PARTS BULLETIN

Models: **135-230 kW John-Deere Powered**

Subject: **Alternator and Engine Wiring Harness Change on 6081 Engines**

Figure 1 Alternator Option Code 3106 Replacement Parts

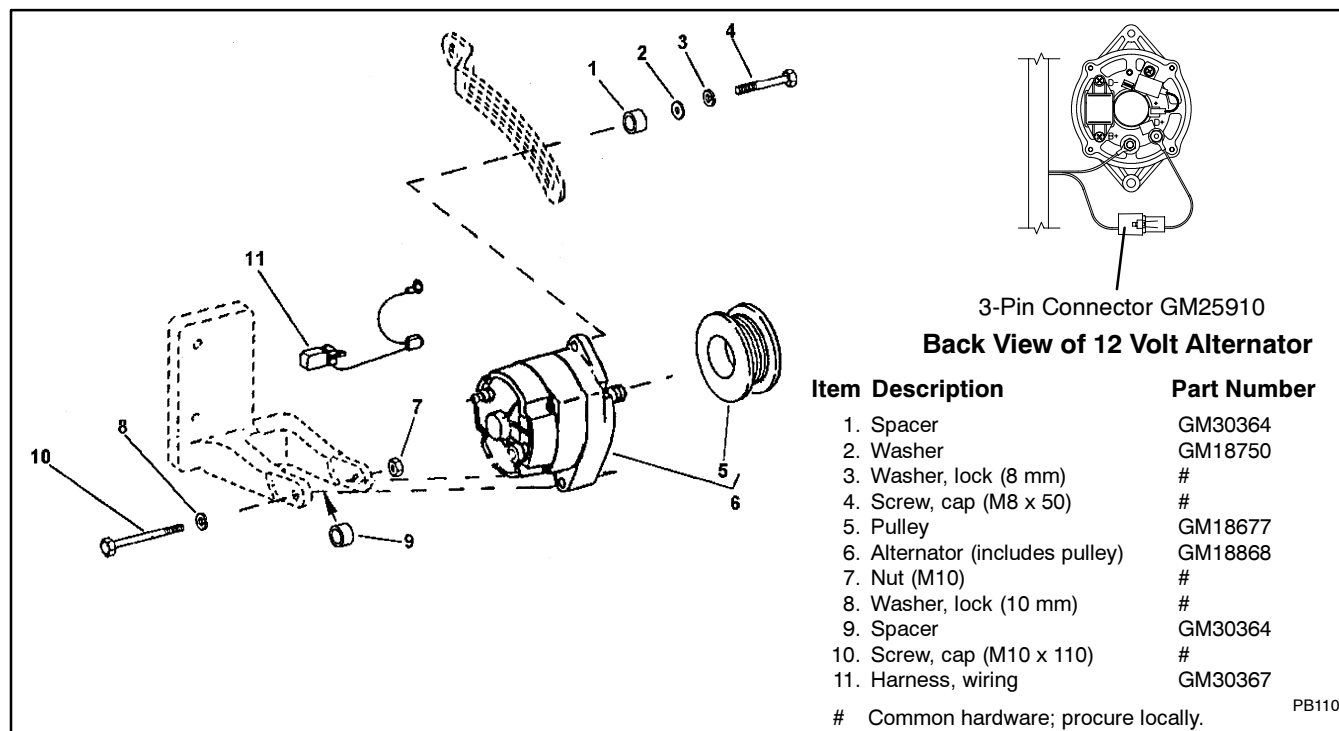
John Deere Power Systems changed the battery charging alternator on 6081 engines. The engine alternator option codes changed and engine wiring harnesses were modified as a result of the change.

When replacing the alternator on subject models, use the engine option code label affixed to the side of the engine block and the table below to determine the alternator replacement part numbers.
